Addendum # 2

Subject: Mary Wright Culture Wall

Hope you are doing well. See below questions concerning the Mary Wright Culture Wall Project:

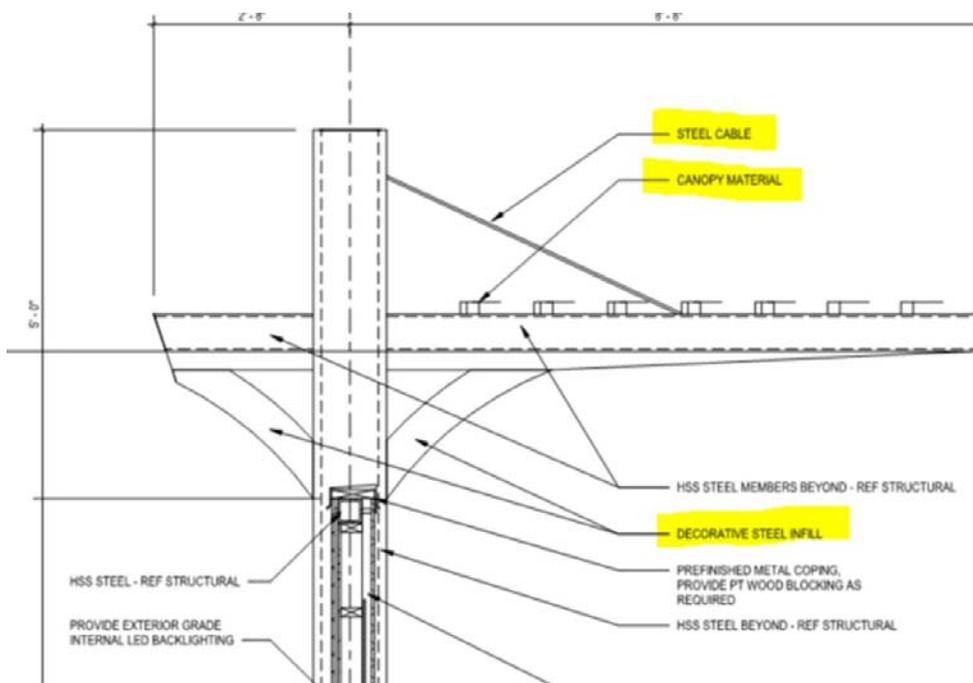
1. Can you provide more information on the material and construction of the decorative steel infill pieces indicated by detail 4/S1.01 and A1/A340?
2. Can you provide more information on the material and construction of the steel cable indicated by detail A1/A340?
3. Can you provide more information on the material and construction of the canopy material indicated by detail A1/A340?

MPS response to question 1: Intent would be for decorative steel infill peices to be Hollow Steel Sections matching width of cross member (4" wide). Connections should be fully welded to structural elements meeting specification requirements for AESS (Architecturally Exposed Structural Steel) Category 3.

MPS response to question 2: intent would be for steel hanger or sag/tie rod, with clevises, mounts, and turnbuckles (if required). Connections should be fully welded to structural elements meeting specification requirements for AESS (Architectural Exposed Structural Steel) Category 3.

MPS response to question 3: intent would be for steel HSS 2x2x1/4 members. Connections should be mechanically fastened into structural members using appropriate anchors to allow for expansion and contraction. Steel should meet specification requirements for AESS (Architectural Exposed Structural Steel) Category 3.

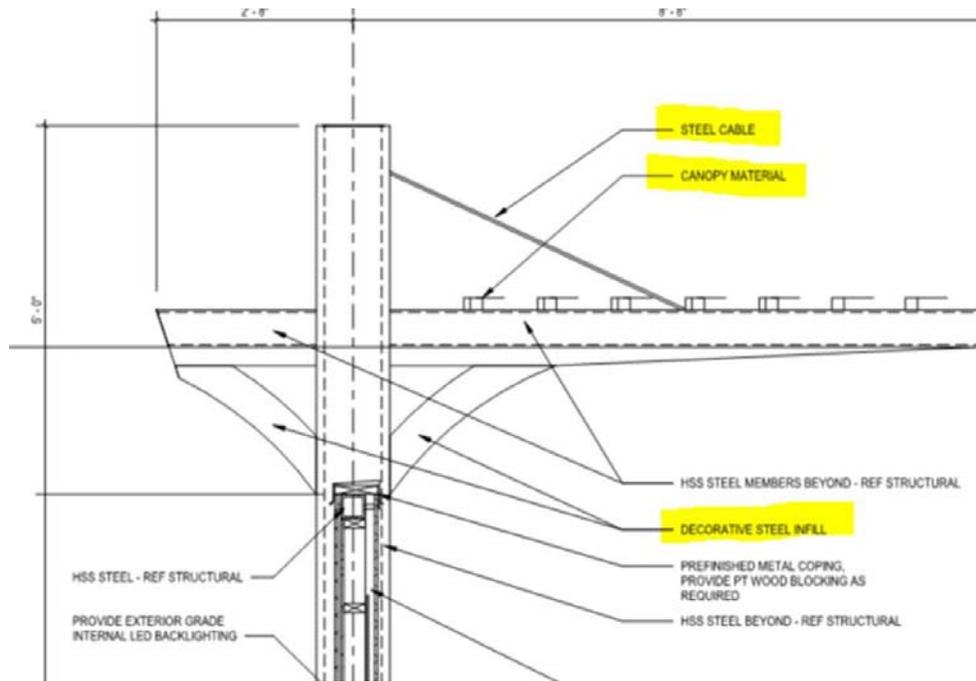
1. Can you provide more information on the material and construction of the decorative steel infill pieces indicated by detail 4/S1.01 and A1/A340?

MPS response to question 1: Intent would be for decorative steel infill peices to be Hollow Steel Sections matching width of cross member (4" wide). Connections should be fully welded to structural elements meeting specification requirements for AESS (Architecturally Exposed Structural Steel) Category 3.

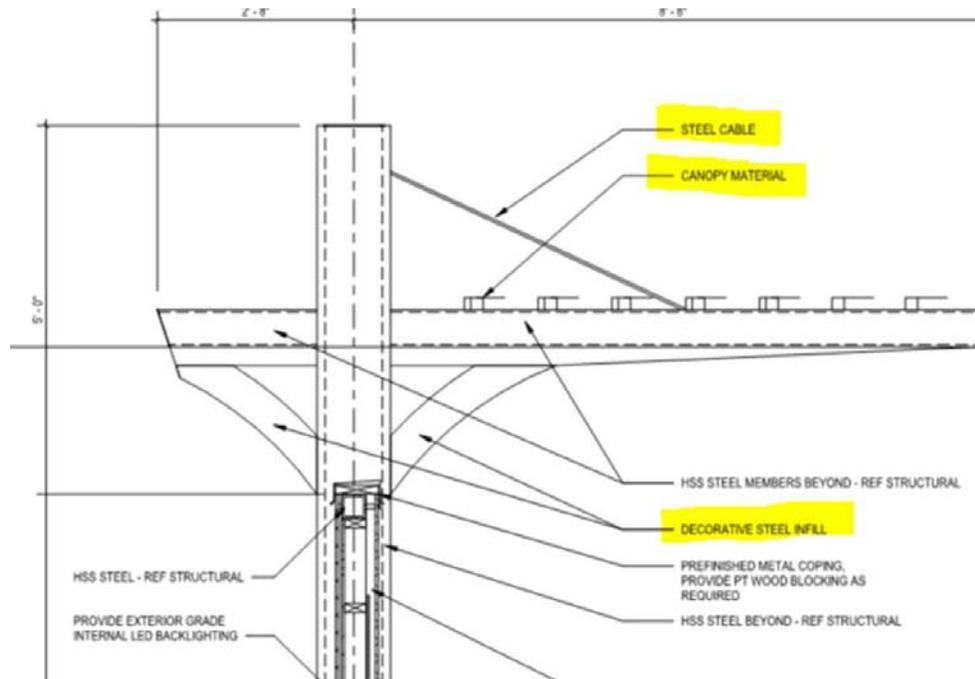
4. Can you provide more information on the material and construction of the decorative steel infill pieces indicated by detail 4/S1.01 and A1/A340?
5. Can you provide more information on the material and construction of the steel cable indicated by detail A1/A340?
6. Can you provide more information on the material and construction of the canopy material indicated by detail A1/A340?

MPS response to question 2: intent would be for steel hanger or sag/tie rod, with clevises, mounts, and turnbuckles (if required). Connections should be fully welded to structural elements meeting specification requirements for AESS (Architectural Exposed Structural Steel) Category 3.

MPS response to question 3: intent would be for steel HSS 2x2x1/4 members. Connections should be mechanically fastened into structural members using appropriate anchors to allow for expansion and contraction. Steel should meet specification requirements for AESS (Architectural Exposed Structural Steel) Category 3.
